# eRHIC IR Design Meeting

Draft Minutes for Friday, March 8, 2019

Figure 1: eRHIC-Hadron.eps

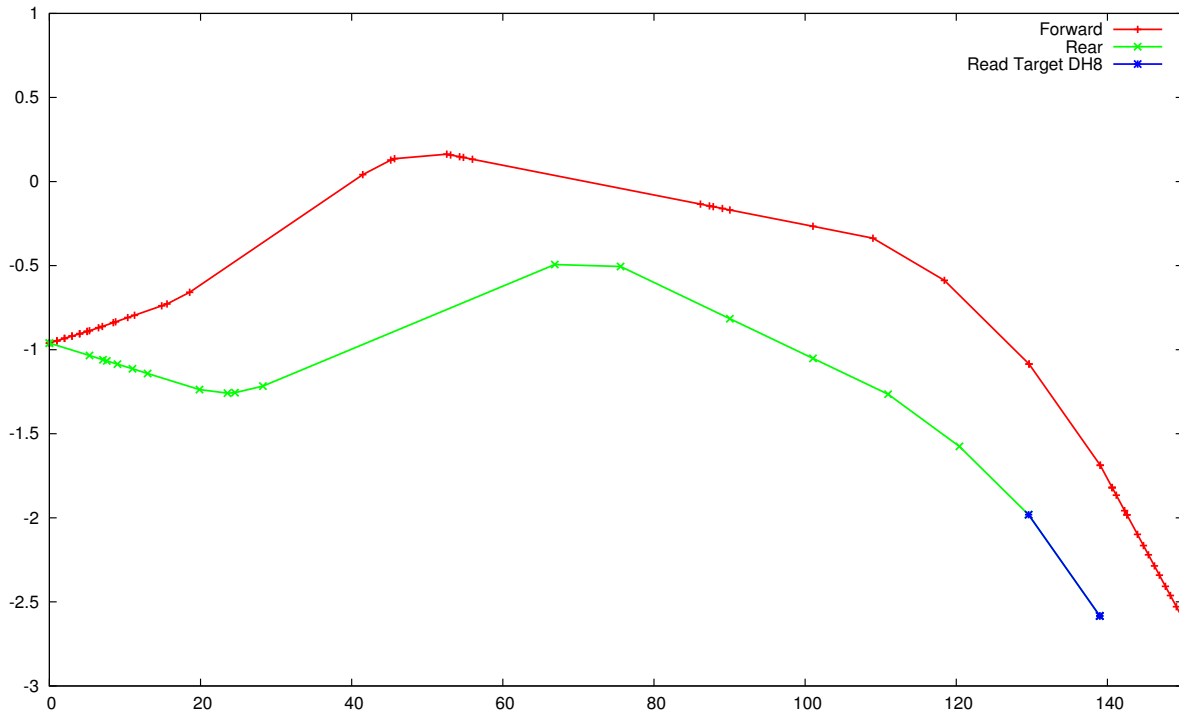
1. Limits of RHIC magnets need to be lowered for 133 GeV.
2. Using DXs and D5s.
3. Can only make it match if electron changed from 8 mrad to 11 mrad (proton changed from 17 mrad to 13 mrad). Otherwise need to cost for new magnets.

4. Using 2 DXs at  $z \sim 25$  m (green) gets rid of D5 at  $z \sim 75$  m (green)  
Difference in green and red at spin rotators is 11 mrad.
5. We need to go to the D8. Need same amount of space for snake as for spin rotators ( $\sim 11$  m).

- (a) Could spin rotators and snake be combined? Maybe.
  - (b) Need 2 rotators and 1 snake.
6. Haven't started optics matching.
7. First 40 m in forward direction is set in stone. The same for 15 m in rearwards direction. (I.e.  $z \in [-15 \text{ m}, 40 \text{ m}]$  is fixed.)

8. Will give Elke geometry from inside crab cavities for simulations
9. This version will be saved and timestamped (for version control) as solution that works, even though we don't have magnet for  $z \sim 75$  m (green).
